Staff Report City of Richmond, Virginia

Commission of Architectural Review

#7 COA-170349-2025	Final Review Meeting Date: 8/26/2025	
Applicant/Petitioner	Arjun Sehgal	
Project Description	Replace 3 vinyl windows on main elevation with 6 over 6 SDL wood windows; alter porch railing style; repaint siding and front door with new colors.	
Project Location	Venable St	
Address: 806 Jessamine Street	2801 2801 2211 2213 2217 2223 2225 2 225 2 225 2 225 2 225 2 225 2 225 2 225 2 225 2 225 2 225 2 225 2 225 2 225 2 225 2 225 2 2	
Historic District: Union Hill	2117 046 Burton St	
High-Level Details:	21/4 812 B14 B17	
The applicant requests retroactive approval for several exterior alterations to a frame building.	804 607 807 812 865 873 815 865 873 815 865 873 815 865 873 815 815 815 815 815 815 815 815 815 815	
The building is a two-story frame, Greek Revival Style cottage ca. 1842.	Cedar St 2230 80 807 816 816 816 816 816 816 816 816 816 816	
Exterior alterations include replacing non-original windows, exterior painting, chimney repairs, and the installation of a new front porch railing.	719 724 725 725 725 725 725 725 725 725 725 725

Figure 1. 806 Jessamine, façade, August 2025.

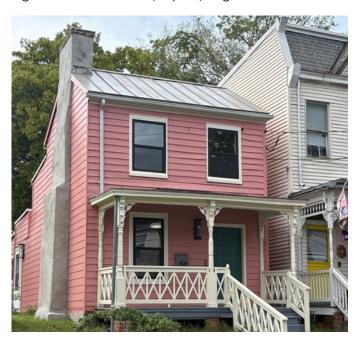
Windows, Window Replacement and/or Reconstruction, pg. 69 when they a repair. Any based on pl	7. Windows should only be replaced when they are missing or beyond repair. Any reconstruction should be based on physical evidence or photo documentation.	Three windows on the façade will be replaced. The living room window (33" x 60") and two upstairs bedroom windows (each 36" x 53") which were white vinyl 6-over-6 grid in between glass windows, most recently replaced without CAR approval with black one-over-one vinyl windows.
		The applicant proposes to replace the one-over-one black vinyl windows with new wood, double hung windows. Staff recommends that the new wood windows installed on the façade be six-over-six with simulated divided lights) SDL'S, final specifications sent to staff for review prior to installation.
Paint	6. Body and trim of building must be painted contrasting colors. 10. Most porches are generally painted white or off-white while the handrail of the banister are often painted a darker color.	The applicant proposes to paint the exterior wood siding Rose Dust (SW005), the trim off-white, and the front door Dutch Tile Blue (SW0031). Staff finds that the off-white trim and light pink body colors create adequate contrast as suggested by the Paint Guidelines and recommends approval of the proposed exterior colors.

This application is the result of a violation.	2200 2207 2209 2209 2209 2209 2209 2209	
Staff Recommendation	Approval, with Conditions	
Staff Contact	Alex Dandridge, Alex.Dandridge@RVA.gov, (804)646-6569	
Previous Reviews	A notice of violation was issued to the property on July 9, 2025.	
Staff Recommendations	The new wood windows installed on the façade be six-over- six with simulated divided lights, final specifications sent to staff for review prior to installation.
